## Exhibit 17

### **Quaboag Hills Public Radio, Inc. Minor Change to WJZZ(FM) at North Salem, New York**

**Channel 211 (90.1 mHz.)  
Has: 0.100 kW DA / -31 meters HAAT  
Proposes 0.440 kW DA / -13 meters HAAT**

### **AMENDED TECHNICAL STATEMENT**

**Figure 2B – Closeup Allocation Study for Proposed WJZZ  
and WMFU (formerly WXHD) in Mount Hope, NY  
(BLED-19950306KD)**

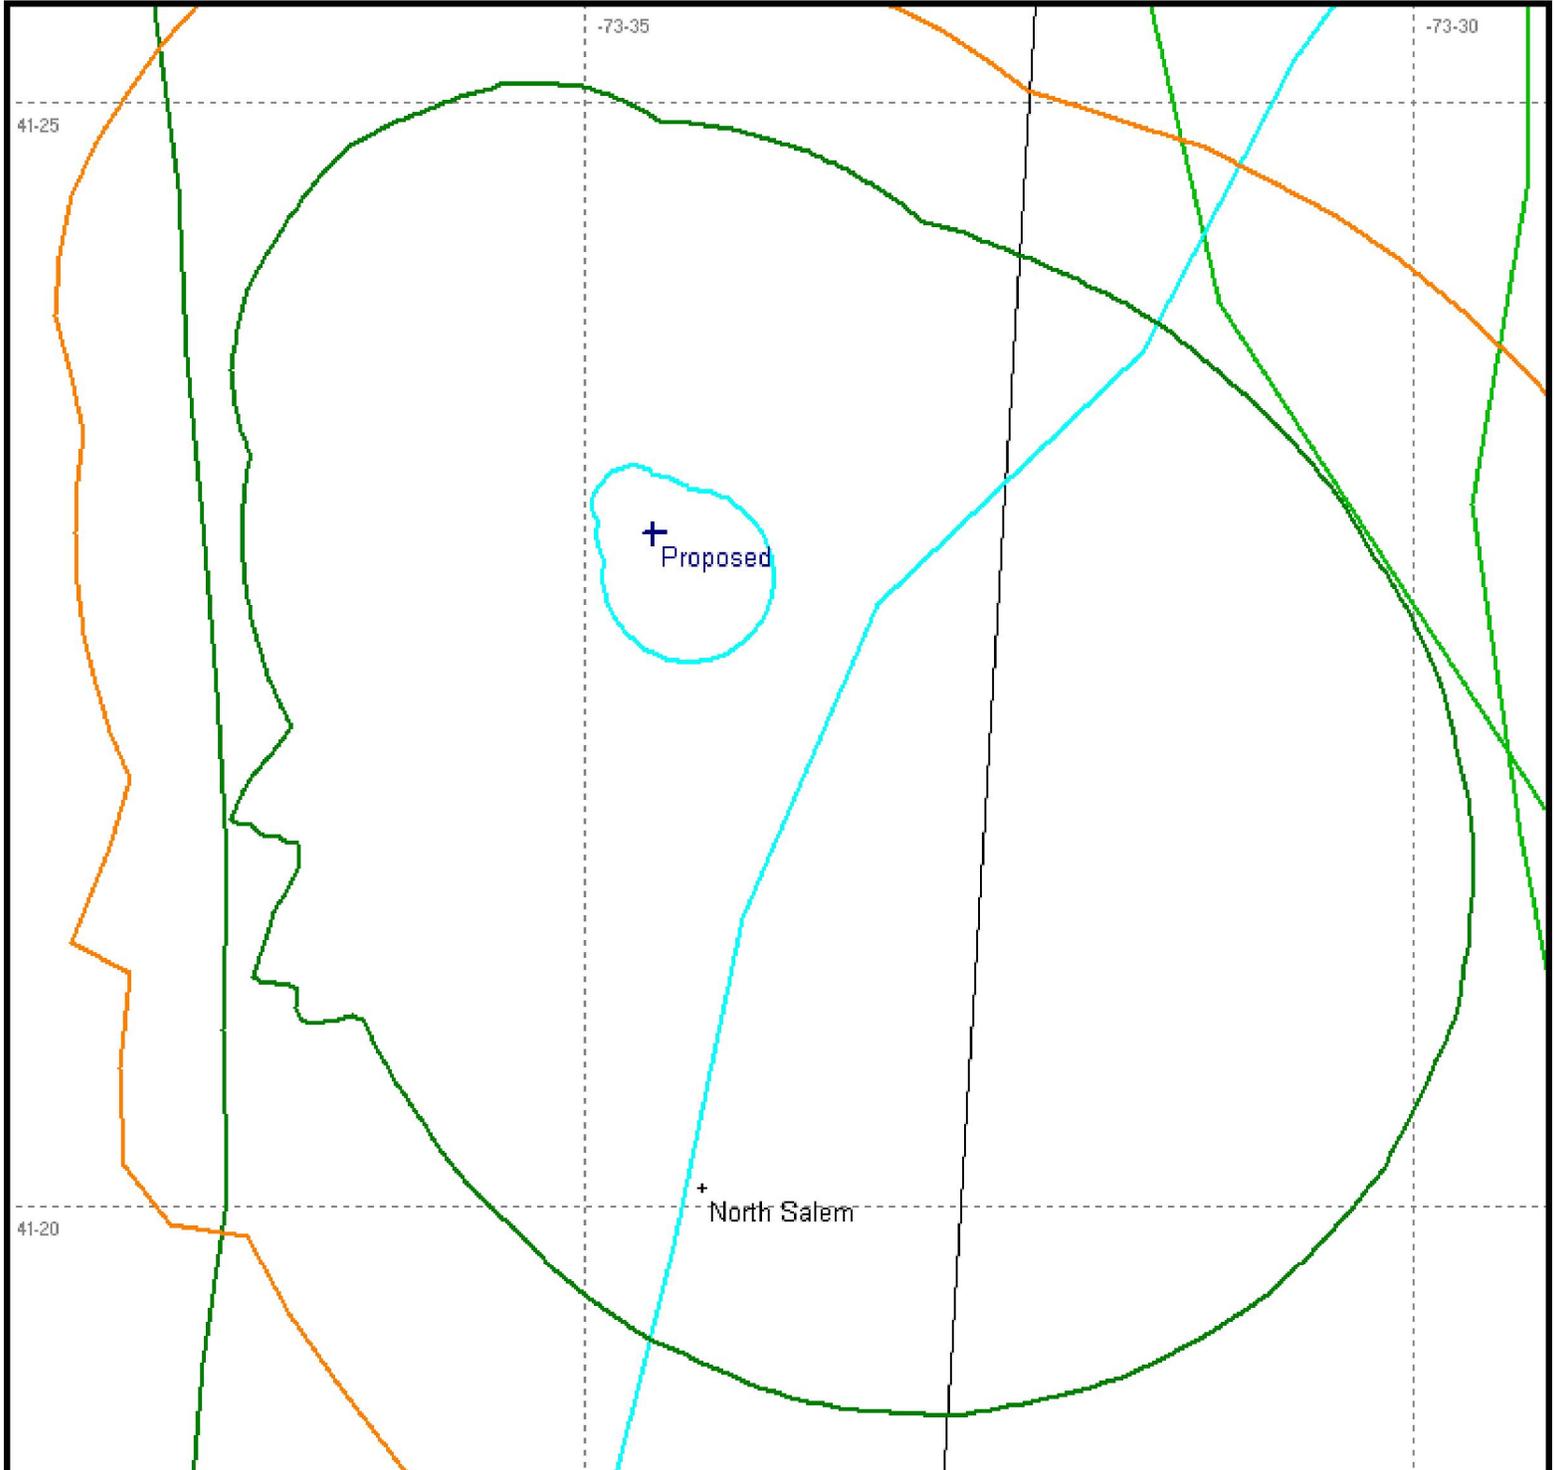
**Overlap from WMFU interfering contour in violation of Section 73.509  
as noted in staff letter of January 13, 2012 has been eliminated.**
